6404 24th Ave NW

Design Review Recommendation - Access to Parking Departure

18 March 2013

DPD Project #3013516

64th St parking garage green wall portal

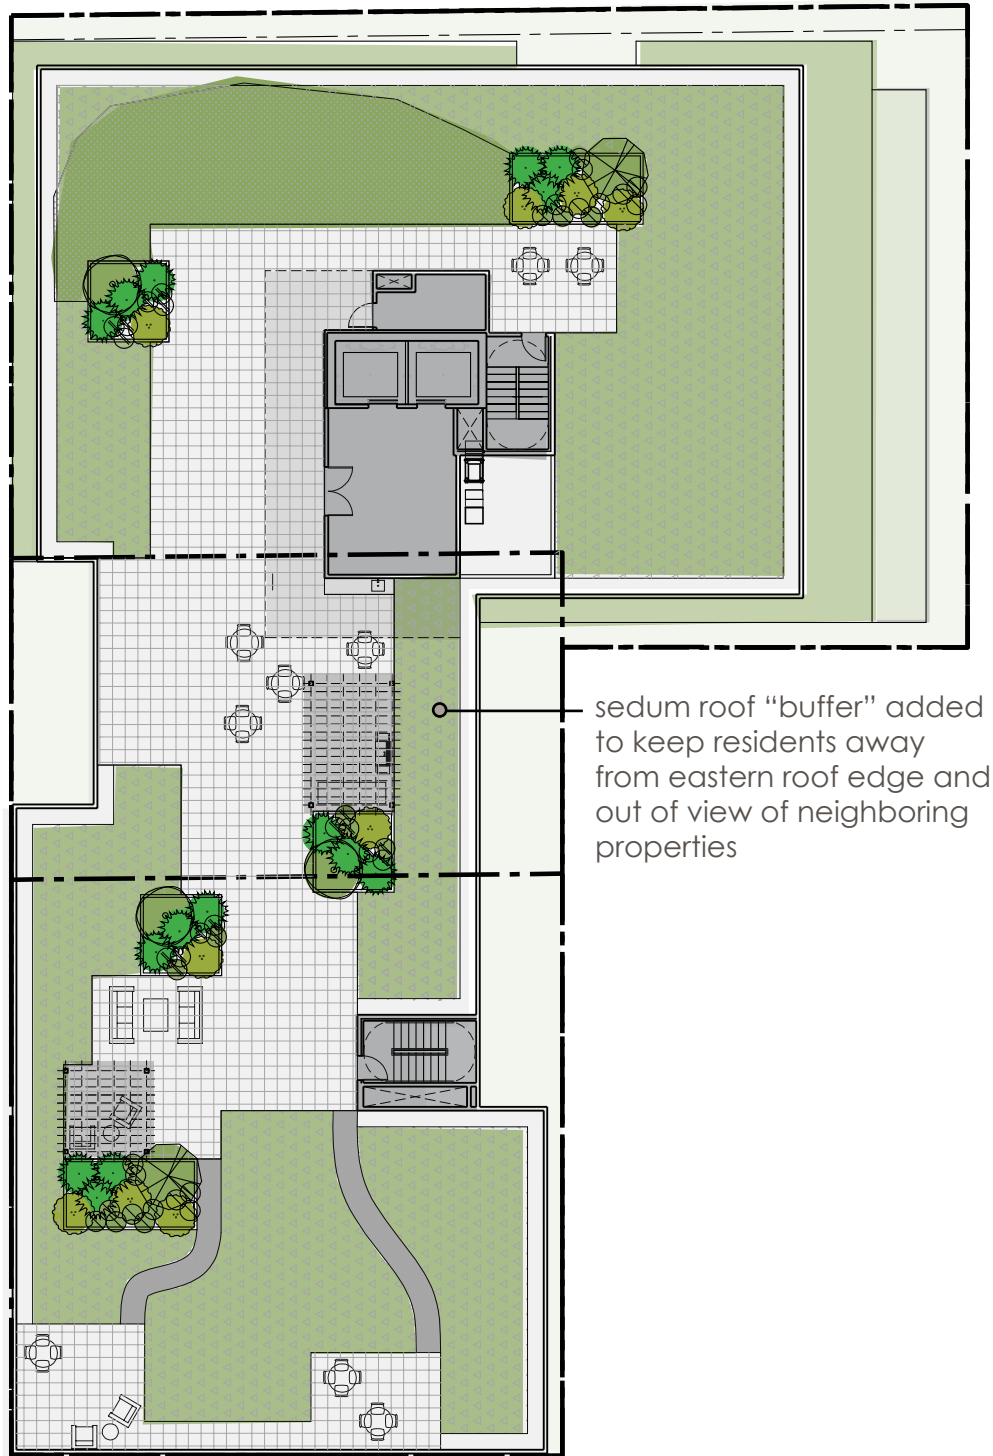
- 1 Develop 64th garage entry portal to provide a better human scale and more landscaping
Height of recess has been minimized to approximately 8'-6" above grade; retail facade continues overhead to provide better connection with adjacent facade. A landscaped green wall and canopy frame the garage entry to form a green "portal" to the garage and courtyard. Safety and security is maintained with keycard-accessible garage and person gates. Nighttime illumination is provided via wall-mounted sconces.
